Architect's Supplemental Instructions

Architect's ASI No: 053

Project:
Webster University
Interdisciplinary Science
Building

Date Issued: 02/24/2017

LEVEL 02 FLOOR PLAN -
AREA B

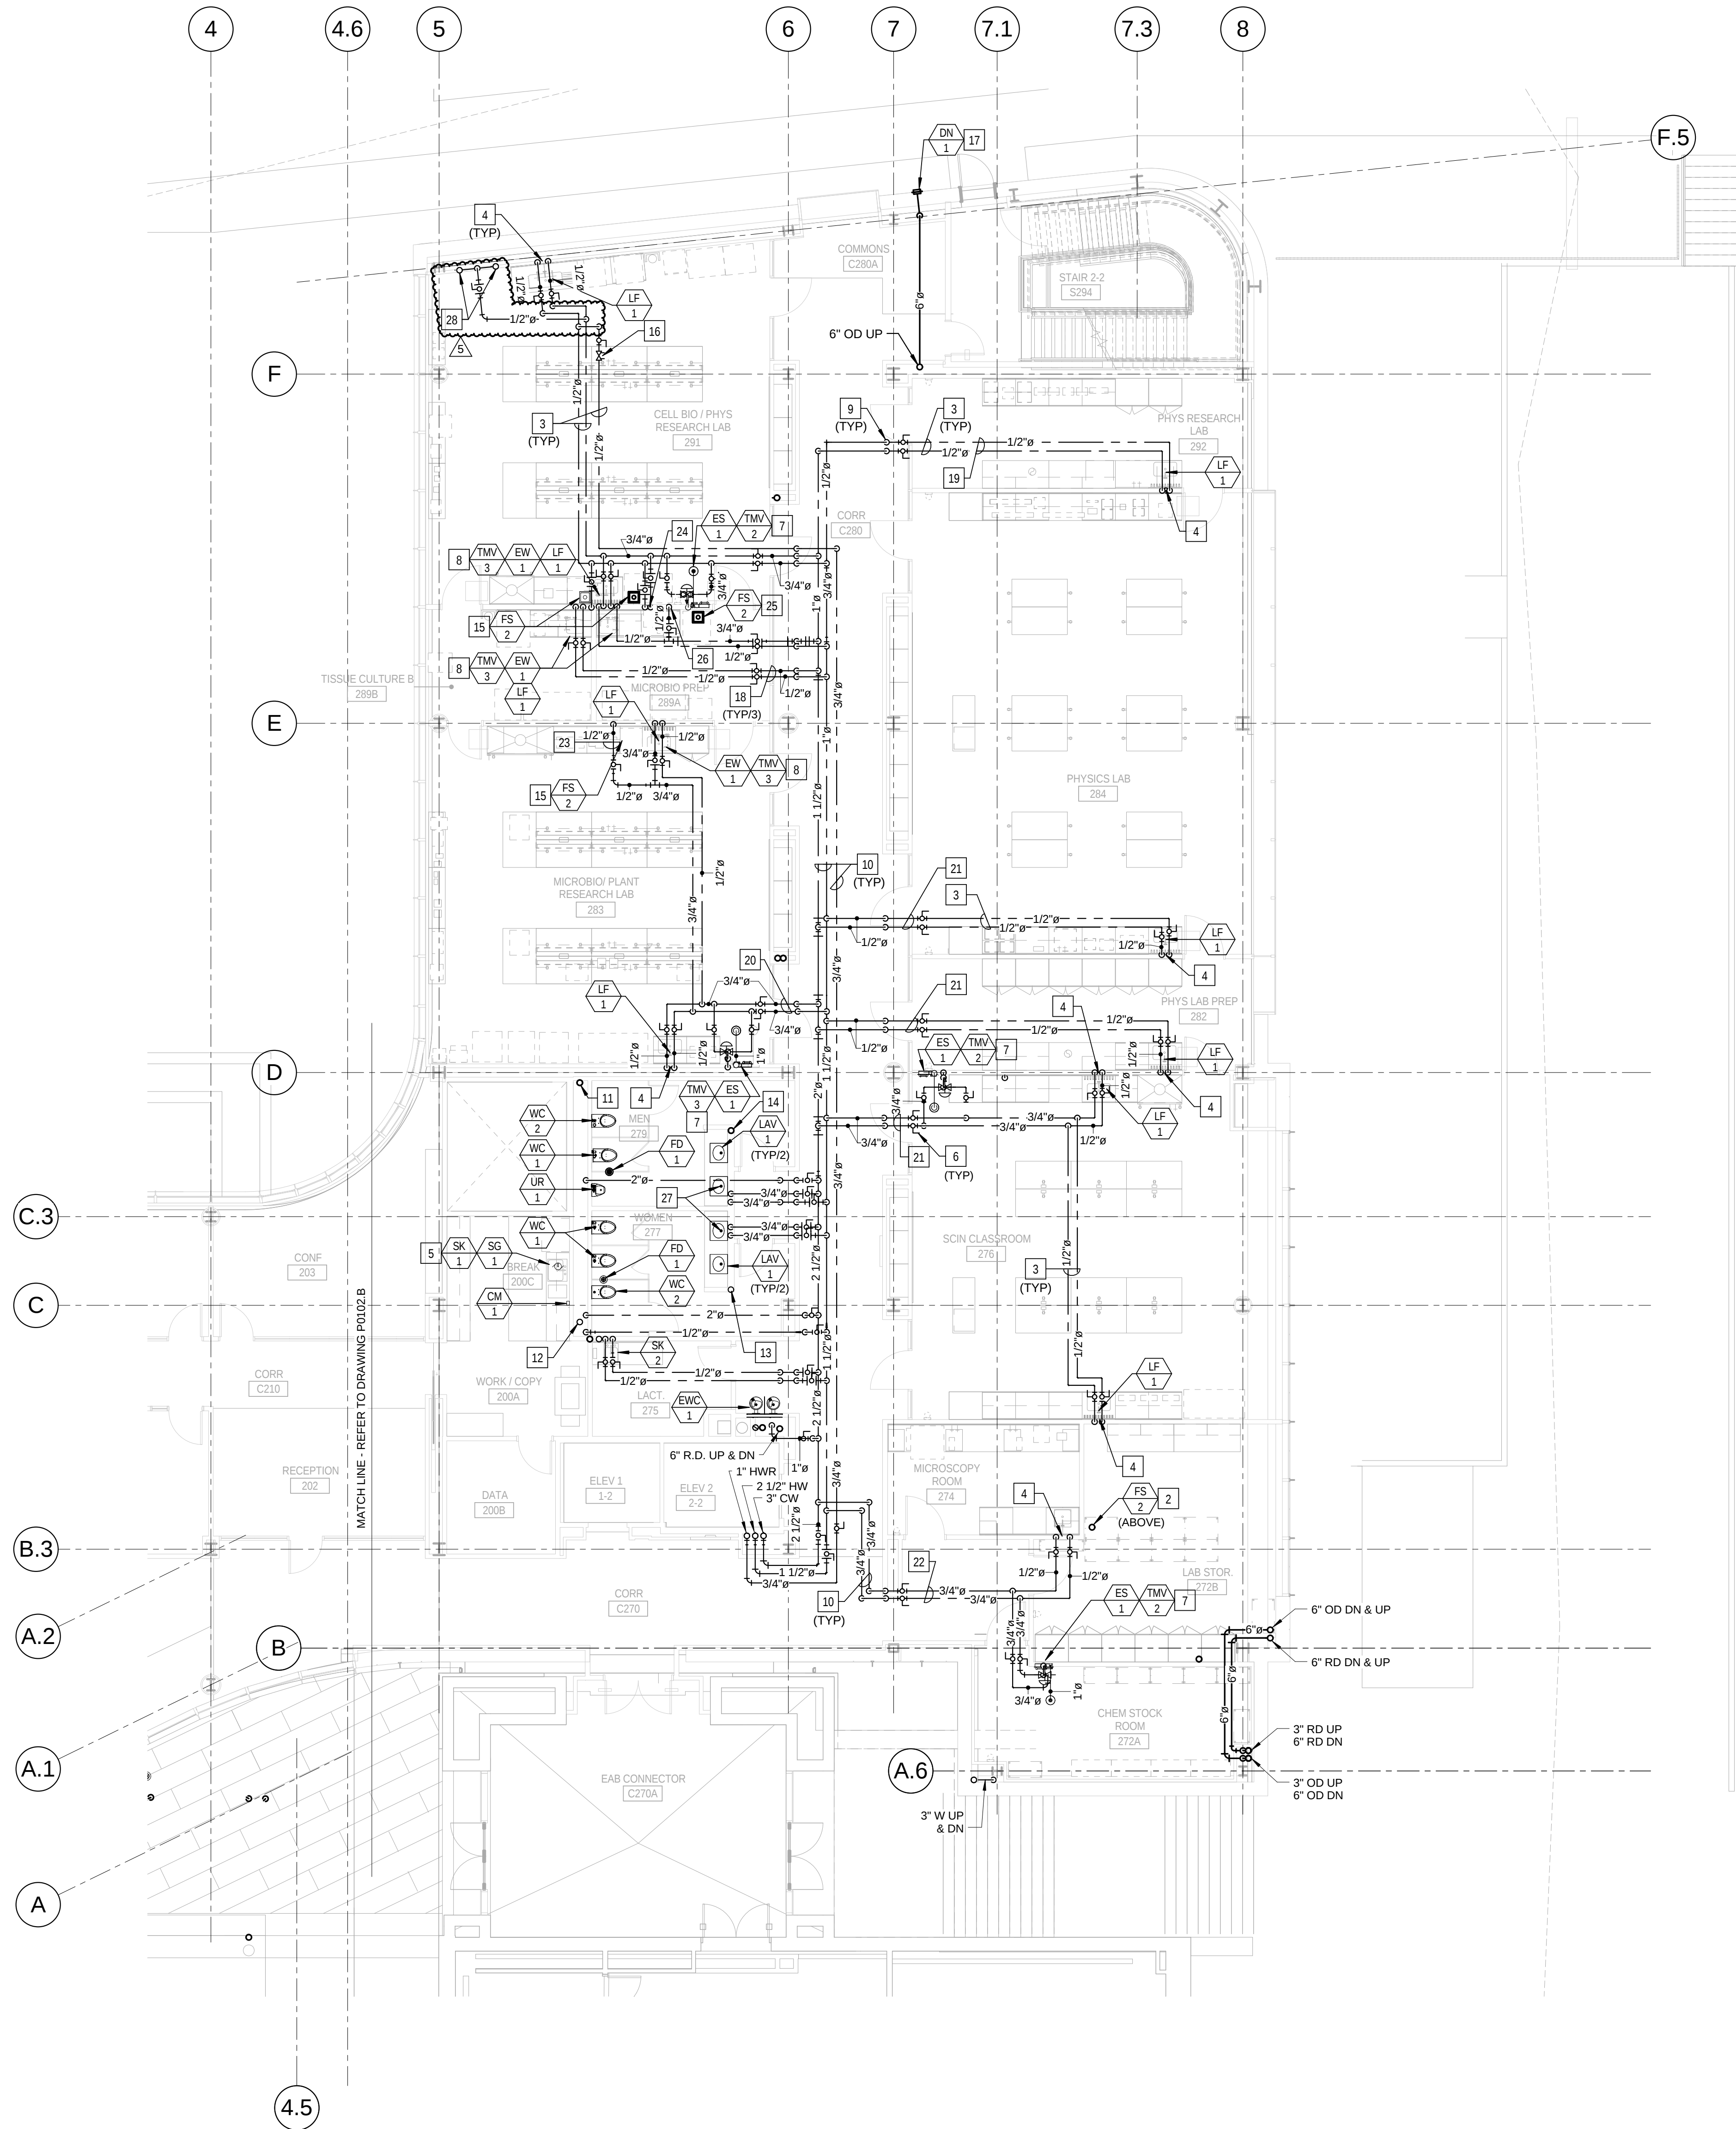
- Add data connection for the Illumina MiniSeq. In Open Research Lab 235.

6 DOMESTIC WATER SUPPLY RISER - PREP 289A - PREP 289B AND LAB 291

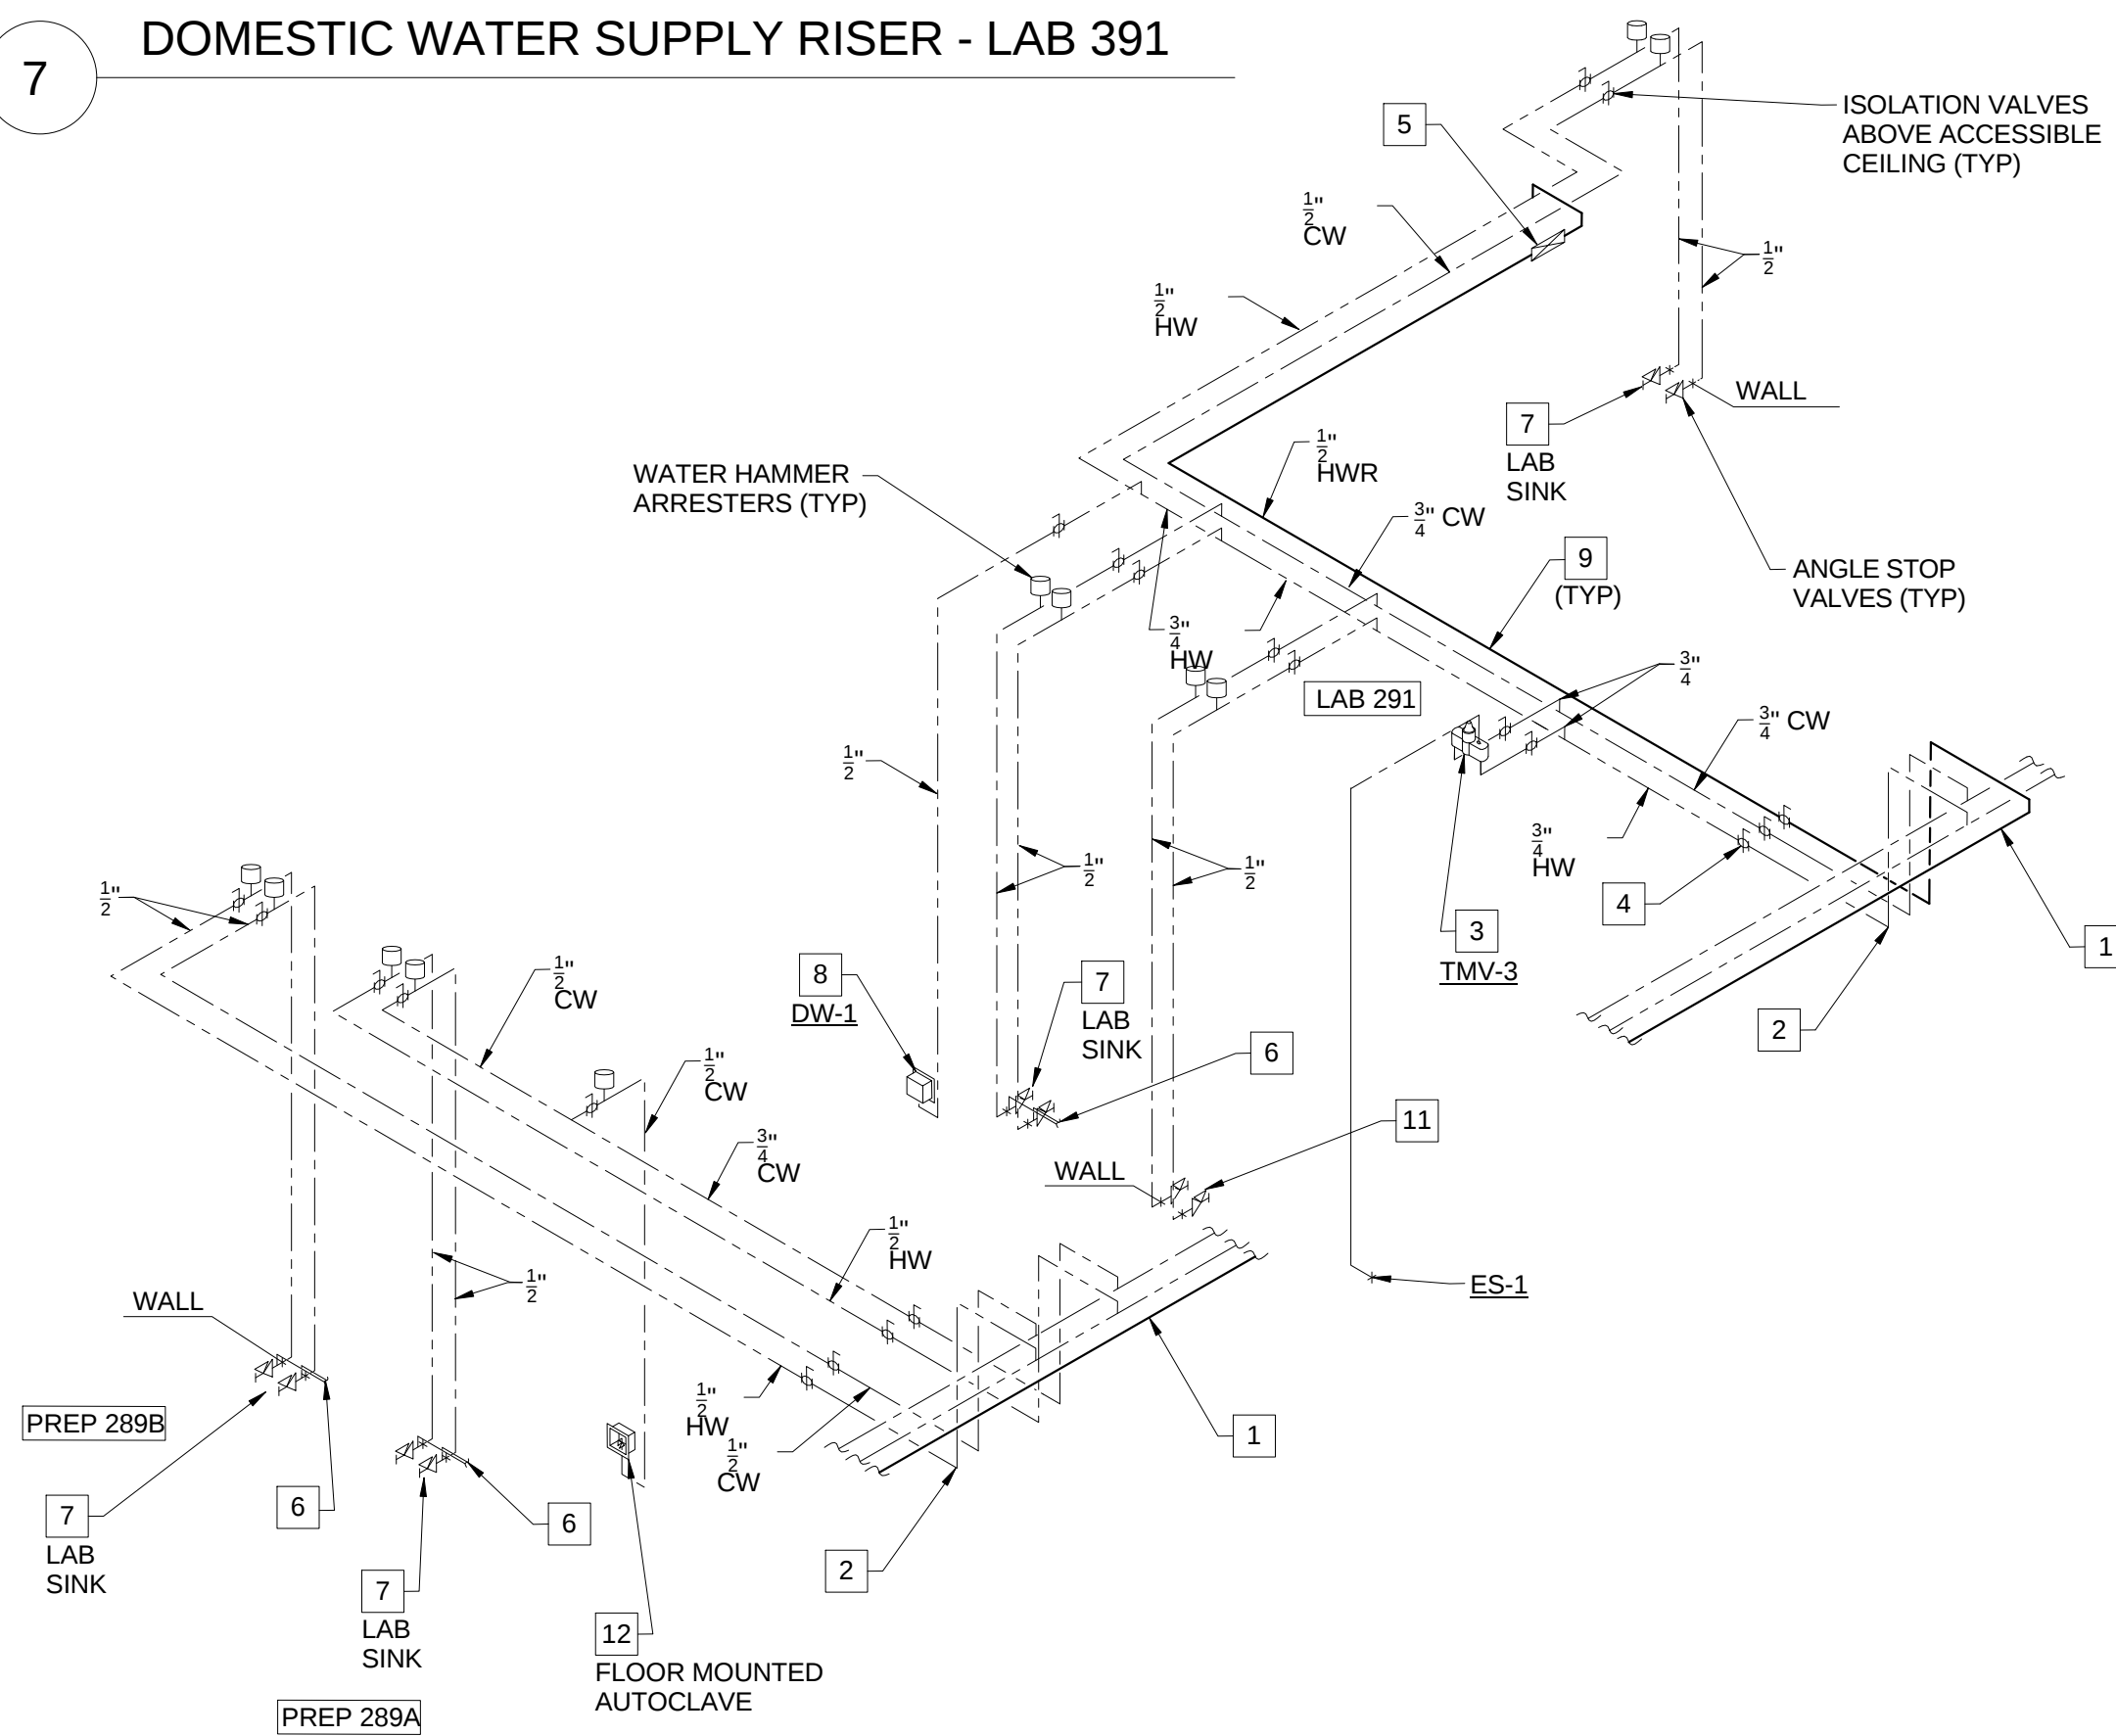
ASI-053, (P0102.A & P0405); 1/2" CW service down in wall to serve future lab equipment. Finish and install two recessed water outlet boxes, type (WD-1). Verify exact equipment placement prior to rough-in. Refer to drawing P405, water supply detail 8.
